Architect's Supplemental Instructions

Architect's ASI No: 045

Project:
Webster University
Interdisciplinary Science
Building

Date Issued: 01/20/2017

1 LEVEL 03 - AREA A - MECHANICAL PLAN

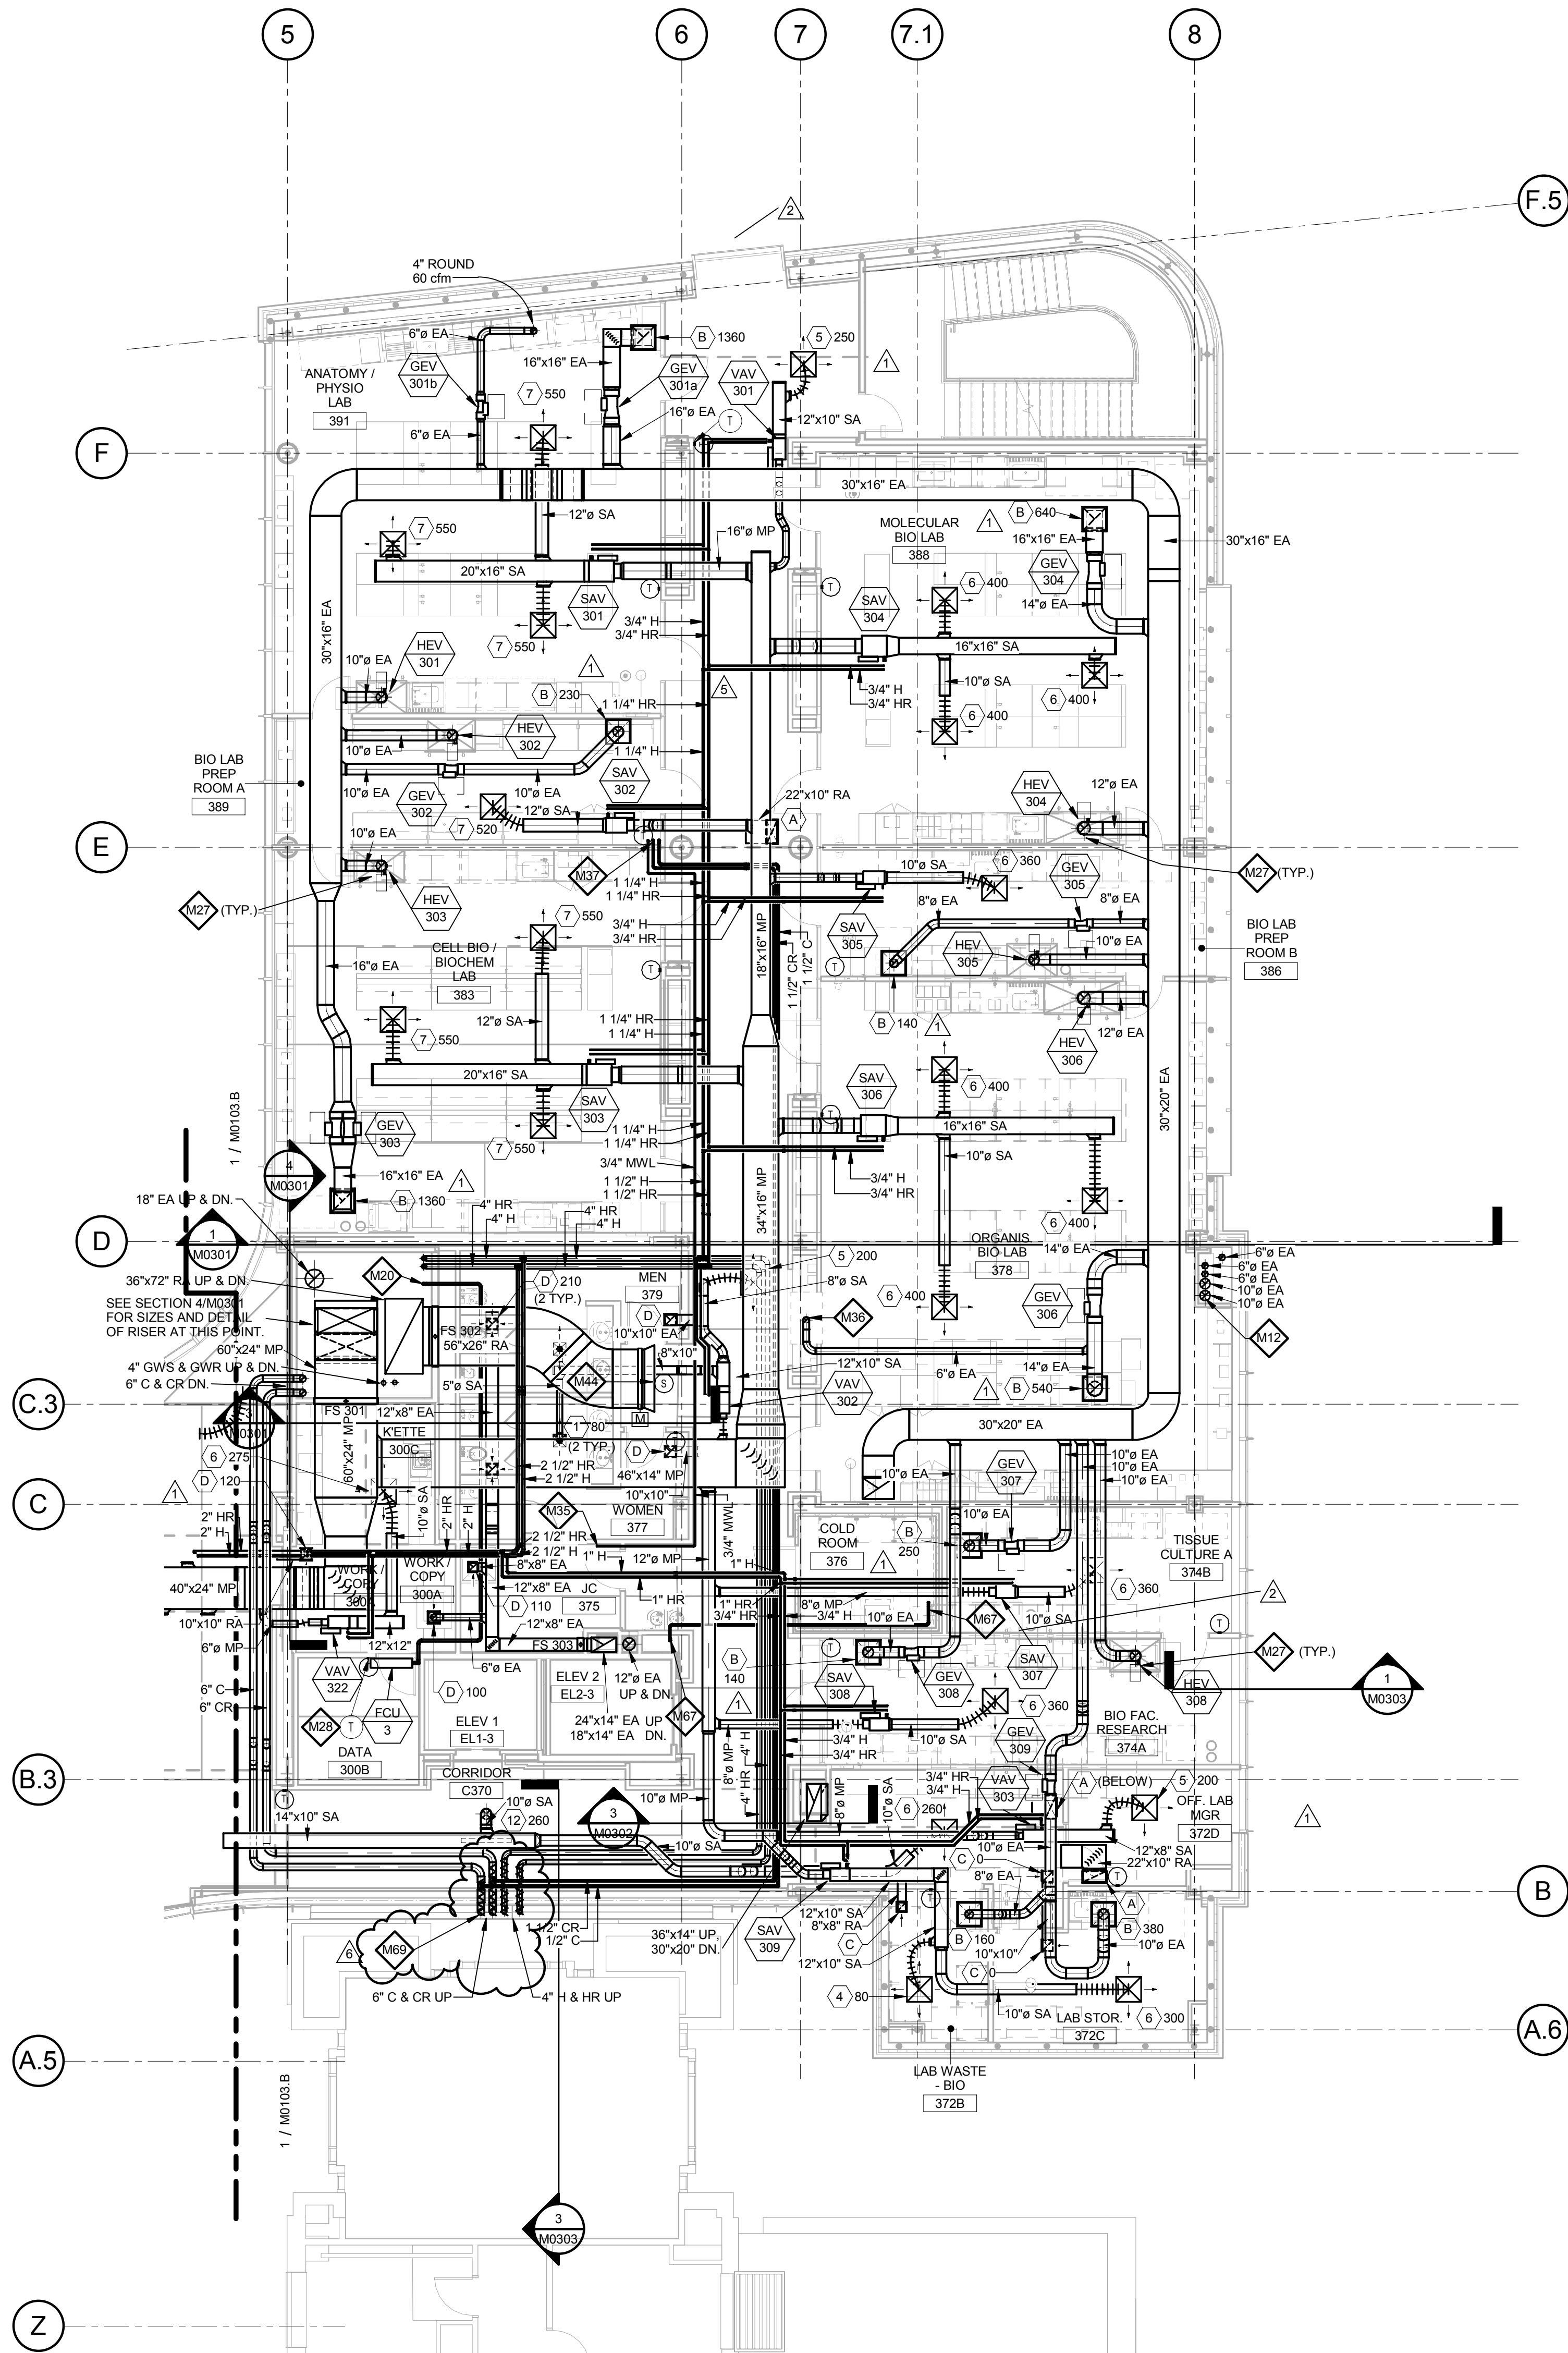
- Shifted H/HR, and C/CR risers north per RFI-408 Contractor proposed pipe routings between buildings.
- Added note M69 referring to electrical plans for heat tracing of H/HR, and C/CR piping.

- M69** HHR AND C/CR PIPING TO BE HEAT TRACED BY ELECTRICAL CONTRACTOR. REFER TO ELECTRICAL PLANS. COORDINATE INSTALLATION OF PIPE INSULATION OVER HEAT TRACE WITH ELECTRICAL CONTRACTOR. HEAT TRACE TO EXTEND 3 FT. INSIDE EACH BUILDING.

1 LEVEL 04 - AREA A - MECHANICAL PLAN
1/8" = 1'-0"

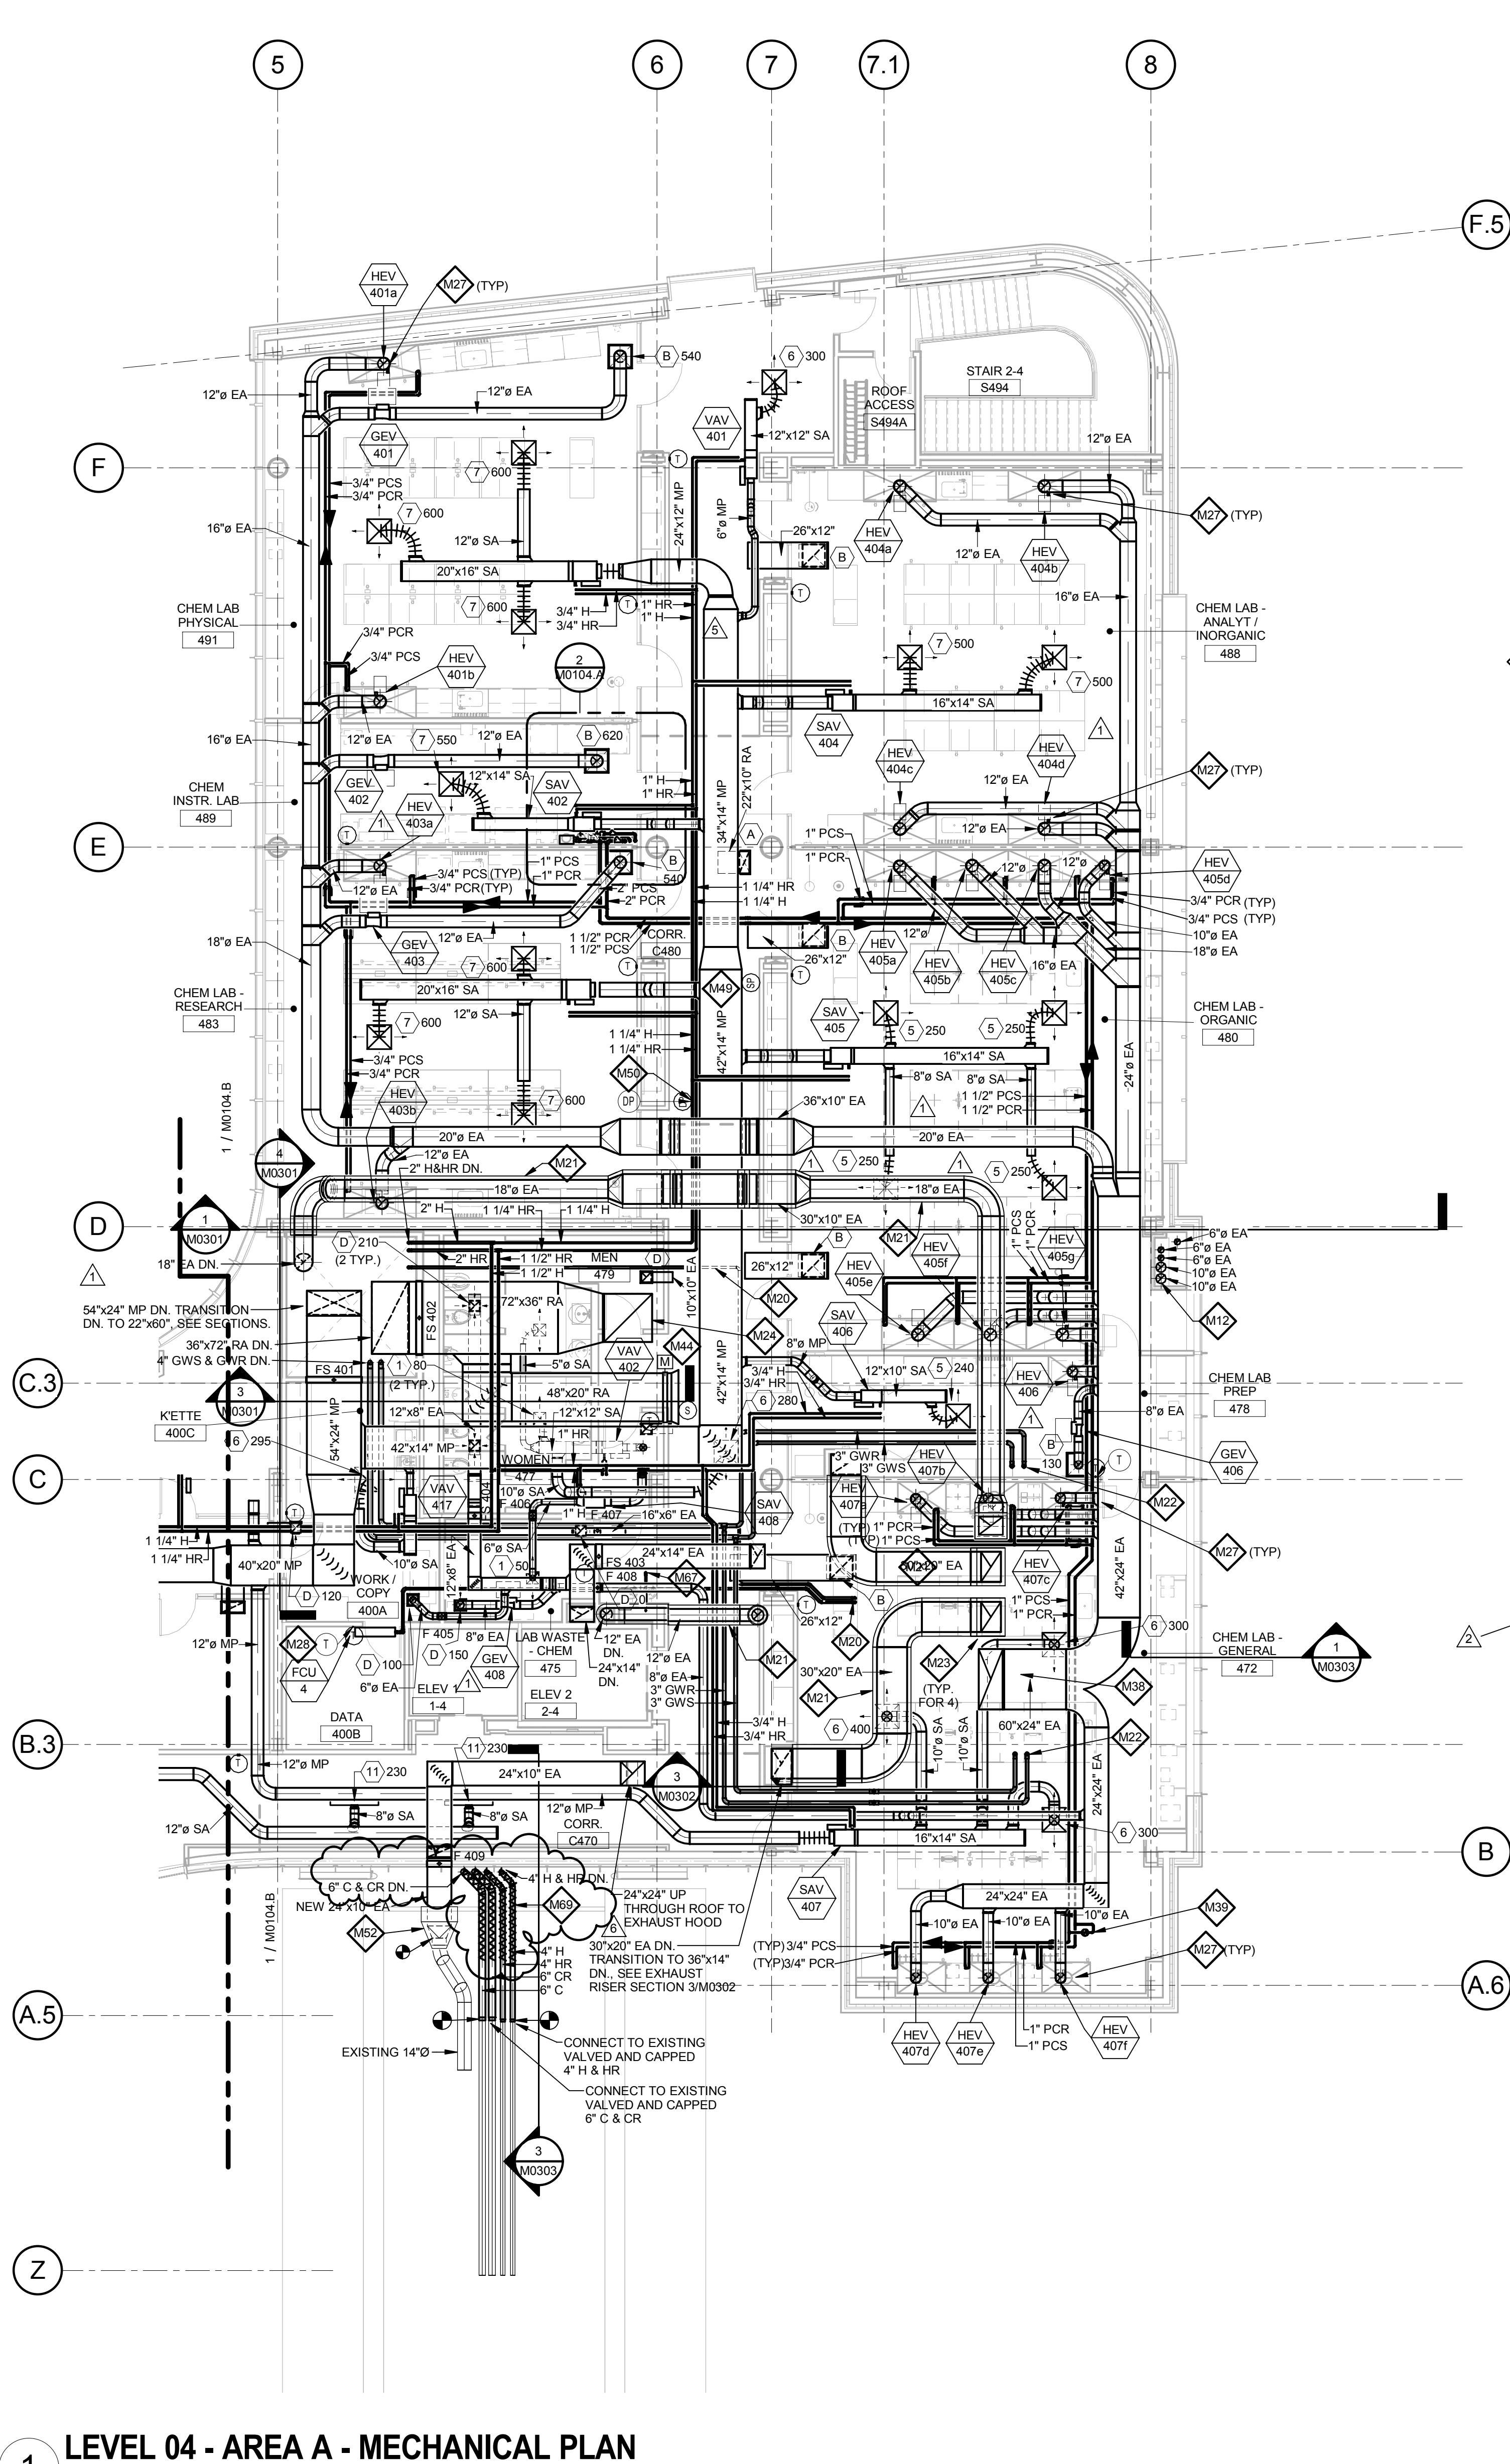
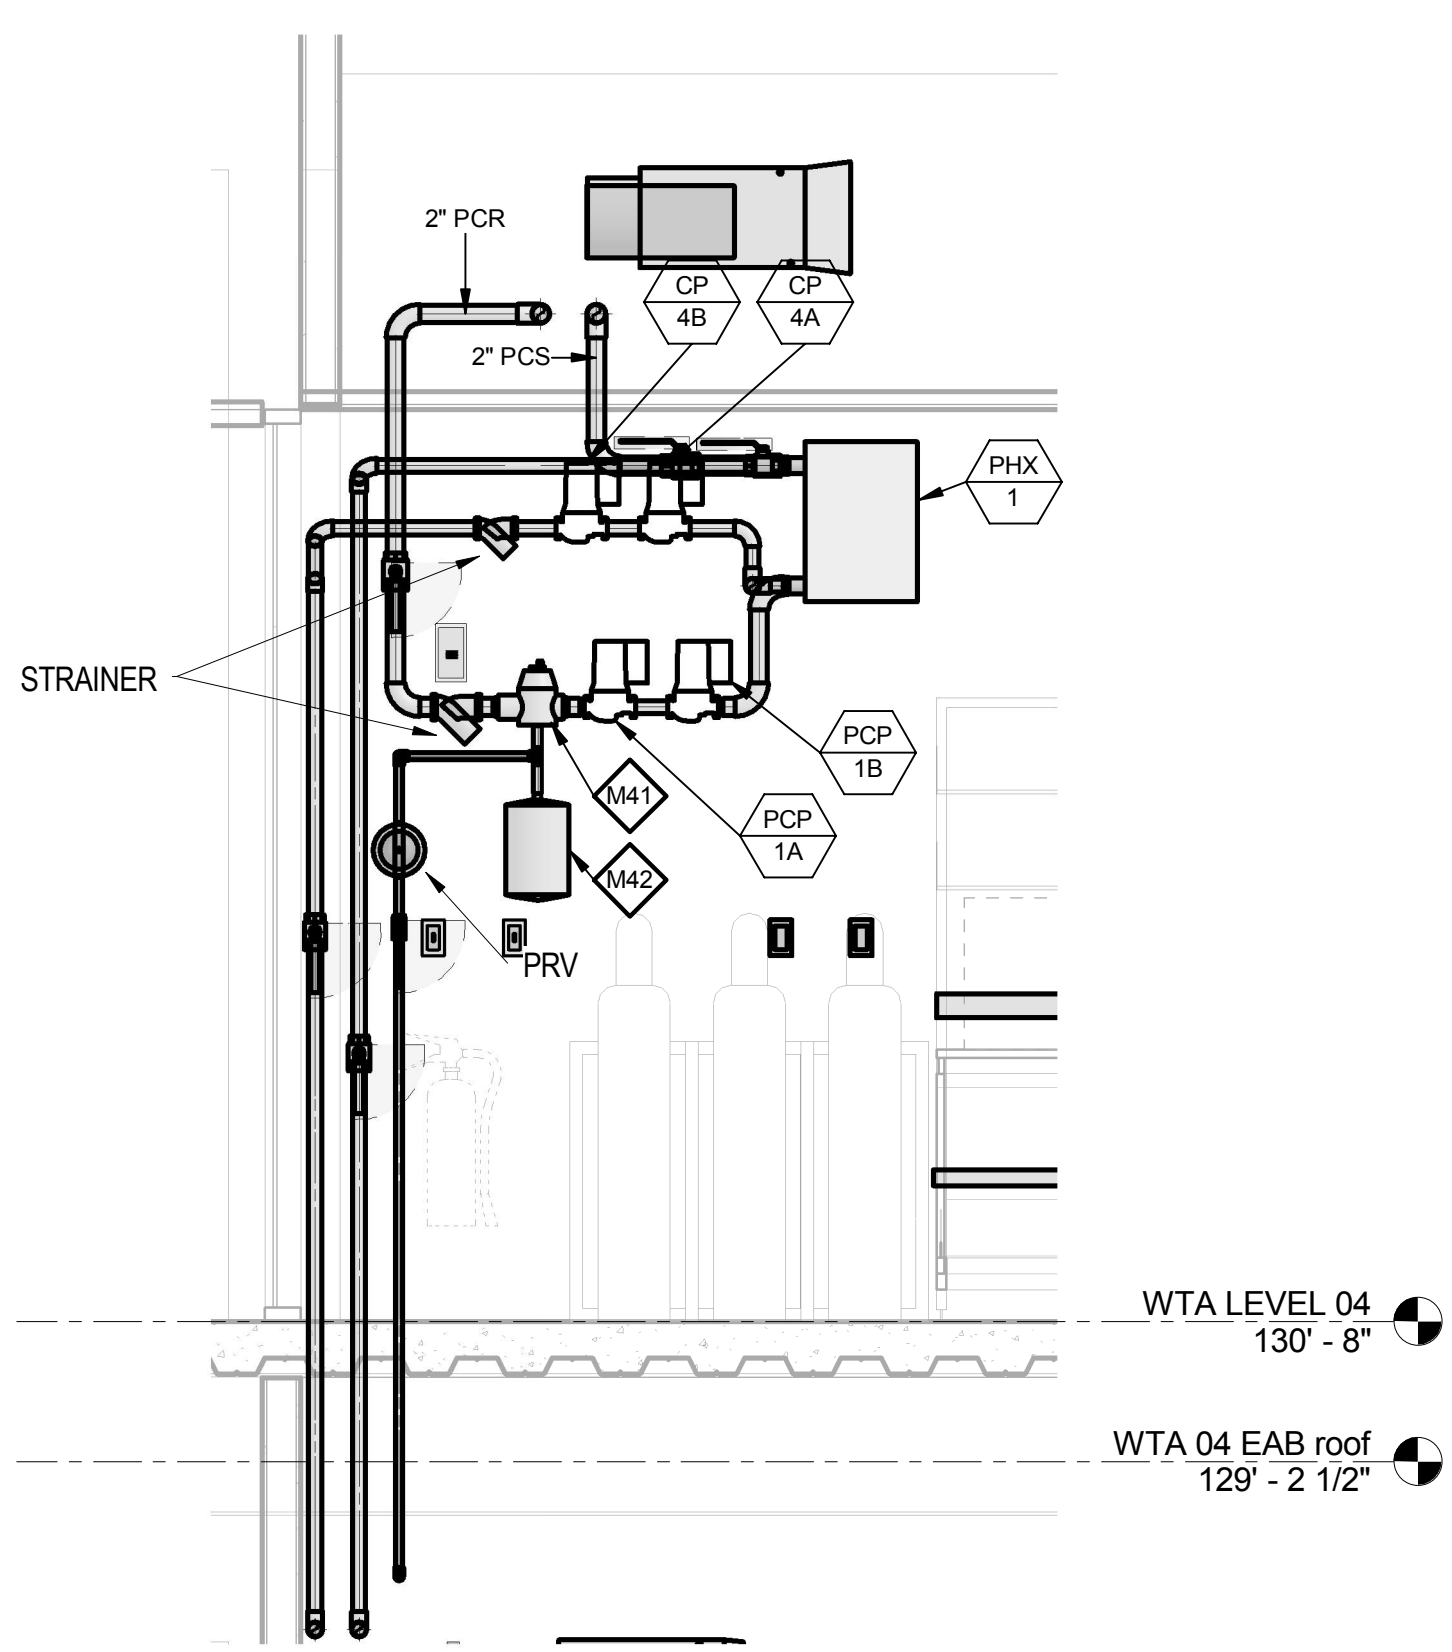
- Shifted H/HR, and C/CR risers north per RFI-408 Contractor proposed pipe routings between buildings.
- Added note M69 referring to electrical plans for heat tracing of H/HR, and C/CR piping.

- M69 HHR AND C/CR PIPING TO BE HEAT TRACED BY ELECTRICAL CONTRACTOR. REFER TO ELECTRICAL PLANS. COORDINATE INSTALLATION OF PIPE INSULATION OVER HEAT TRACE WITH ELECTRICAL CONTRACTOR. HEAT TRACE TO EXTEND 3 FT. INSIDE EACH BUILDING.
